Responses to questions Mr Blair put Mr Johnson following review of the email discussion trailing the questions. Mr Johnson's responses in red.

a. Capacity in the relevant vacuum sewer system

Subject: RE: RMA/2024/2460 Mitre 10 flow rate conformation

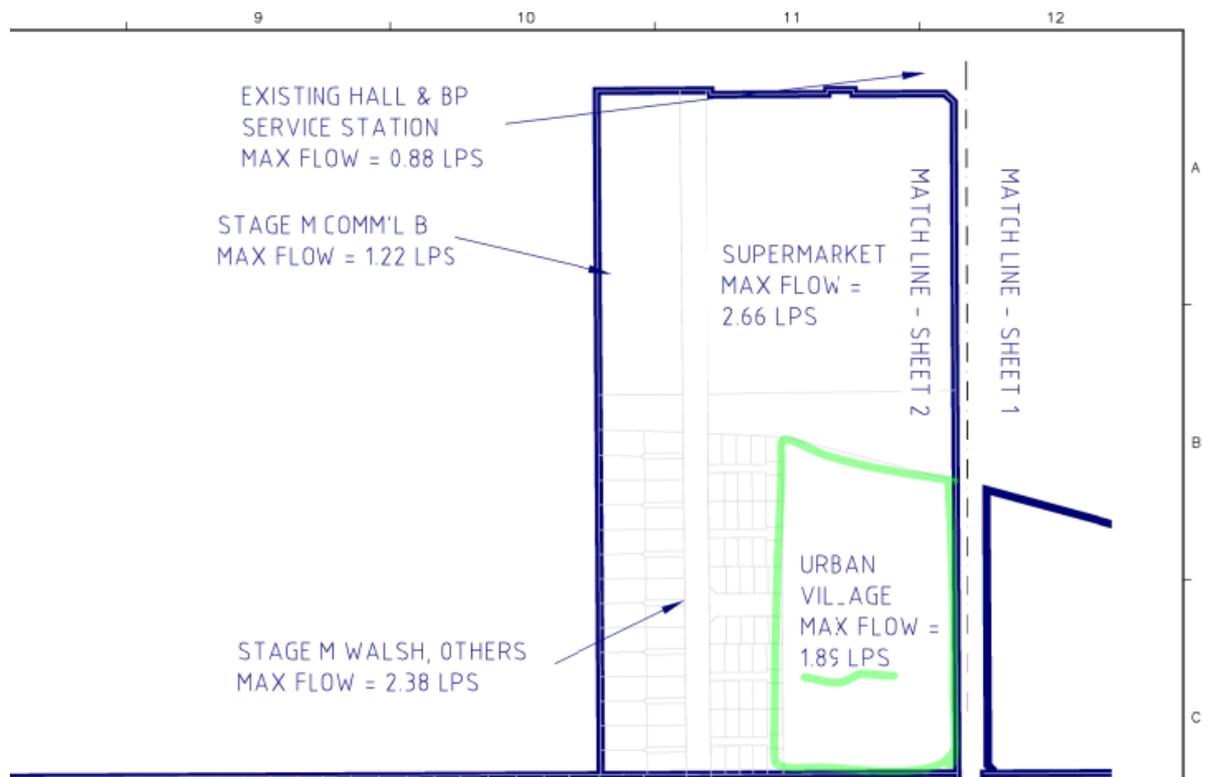
1. Ian, the Council has previously advised that the M10 building is to discharge to Georgina Street. I note from your email from yesterday that the design discharge limit is 0.8 l/s PWWF to Georgina Street. Given that Cheejos IDS based calculation for M10 is currently 0.79 l/s, does this mean that the northern retail blocks need to discharge to Prestons Road? **YES, whilst the existing DN125mm vacuum lateral in Georgina Street can accommodate more than 0.8 l/s based on the lateral's capacity, there is a downstream constraint which is why only a DN125 lateral (instead of a DN160) was provided to service #394 Prestons, with the intention being that it would serve the rear of the site which couldn't achieve gravity to the vacuum ww outfalls in Prestons Road. Therefore, I confirm that Babbage's PWWF (MF of 0.79l/s – 1.1l/s) for just the Mitre 10 Mega complex can be accommodated by the Georgina Street ww gravity outfall (DN125) lateral.**

2. Ian, please advise if the council requires the northern retail shops to discharge to Prestons Road then please confirm capacity for the Prestons Road discharge location once you receive Cheejo's updated calculations. **The attachment is the latest update I've received from Flovac for this site which is referred to as the 'Urban Village' and confirms there is capacity in the Prestons Road ww vacuum main for the future development to the north based on the estimated PWWF(MF) design flow from Babbage of 0.67l/s. Indicative**

connections (3) have been shown with a total discharge from the site of 3.87l/s.

Original Vac Catchment Design Flows

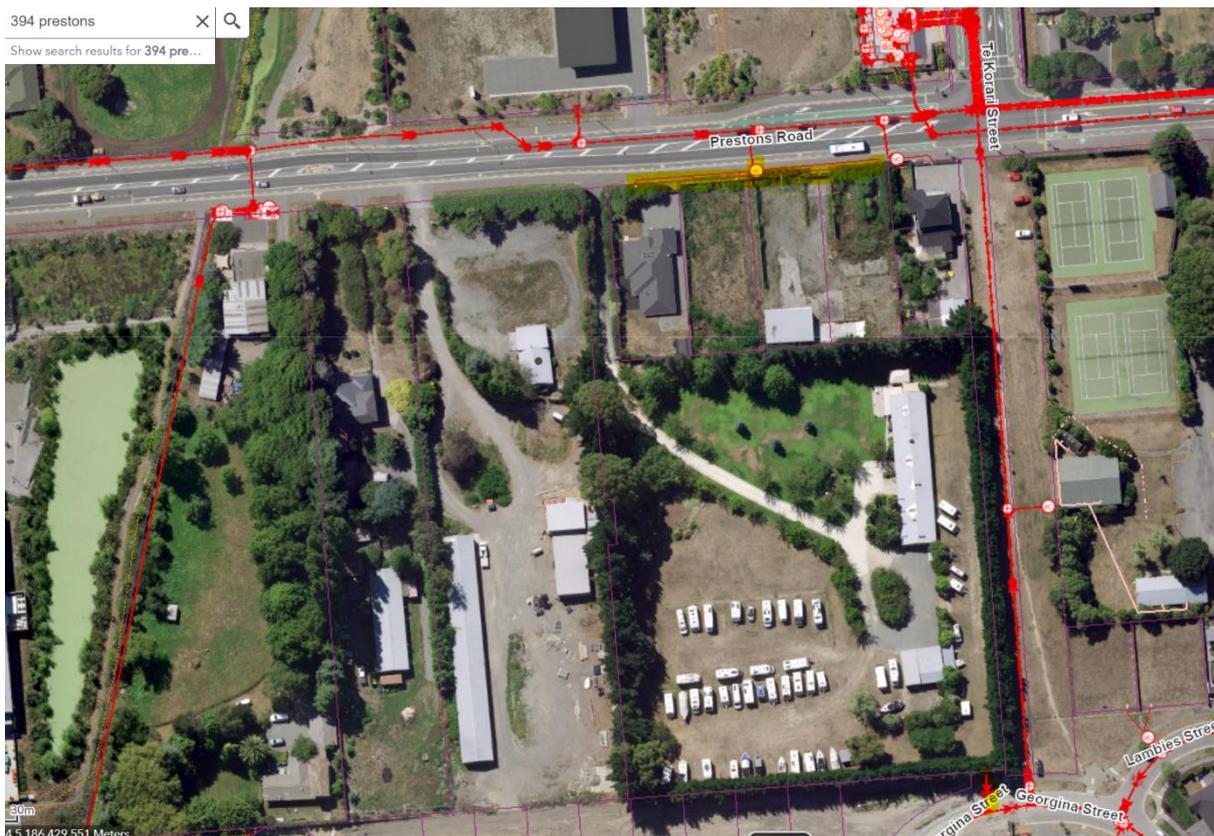
Existing vacuum reticulation with vacpit and 150dia. gravity laterals (highlighted) which can be utilised to service some of the future northern development
